SERVICE BULLETIN

No. 561

Piper Aircraft Corporation

Battery Power Lead Relocation

REAR VIEW OF INSTRUMENT PANEL

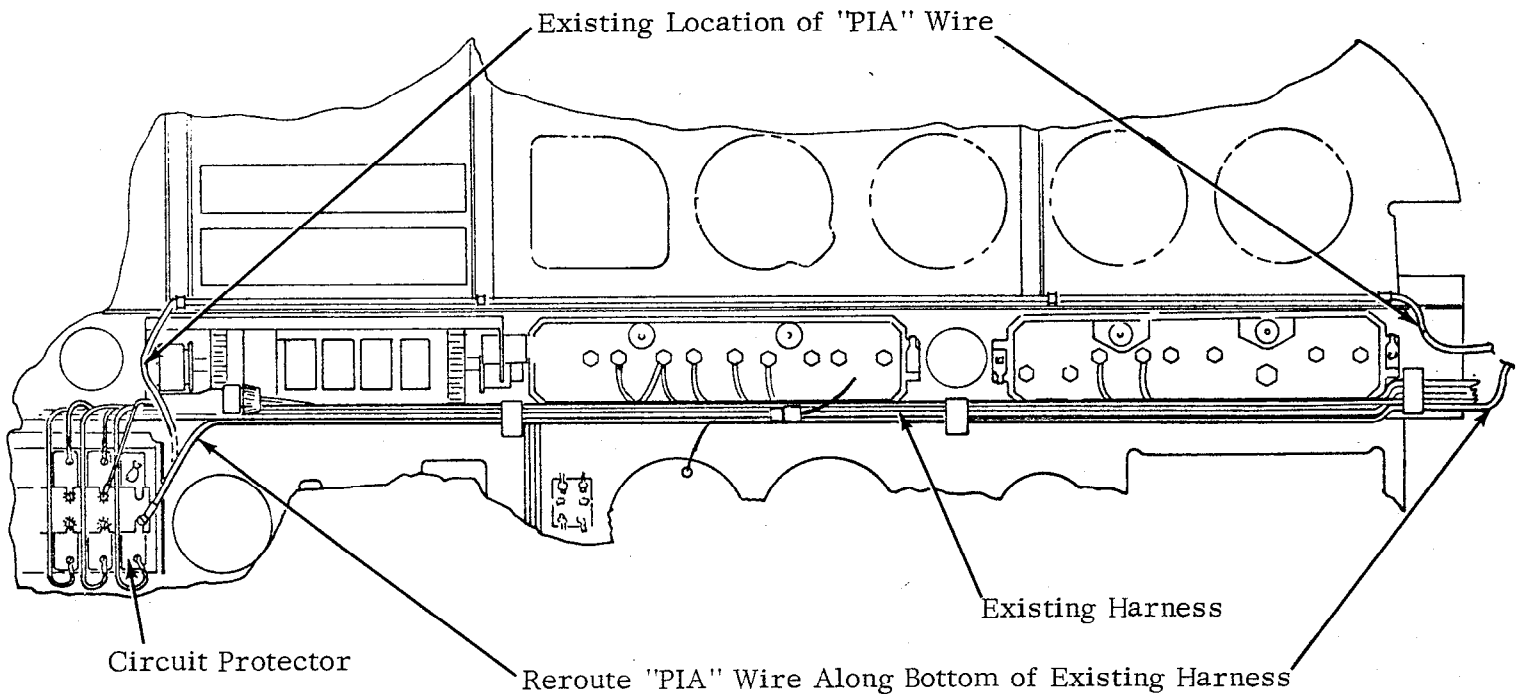
Purpose: It has been determined that the battery power lead that attaches to the DC bus, and is routed in close proximity to the fuel gauges, can induce an electrical field into the coils of the fuel quantity gauges. The amount of induced electrical field will depend upon the amount of electrical equipment turned on by the pilot. This induced field could cause the fuel quantity gauges to read as much as four (4) gallons fuel remaining when the tanks are actually empty.

Part II. Instructions for relocation of battery power lead.

5. Refer to sketch:
 - a. Remove the four (4) each clamps securing the (P1A) wire to the top of the instrument panel channel. The clamp screw located between the radio stacks (over the dimmer control) is secured in a nut plate. This screw should be reinstalled after clamp is removed. This screw may be reached through the right radio opening.

- b. Disconnect the wire (P1A) from the circuit breaker bus bar and pull to the left (Pilot) side panel.
 - c. Reinstall the wire (P1A) under the instrument panel wire bundle, securing the wire with the existing strap clamps. It may be necessary to secure the wire to the existing wire bundle between strap clamps.

- d. Attach the wire to the bus bar using hardware and location removed in step "b." above. Any extra wire should be positioned behind the left side panel.
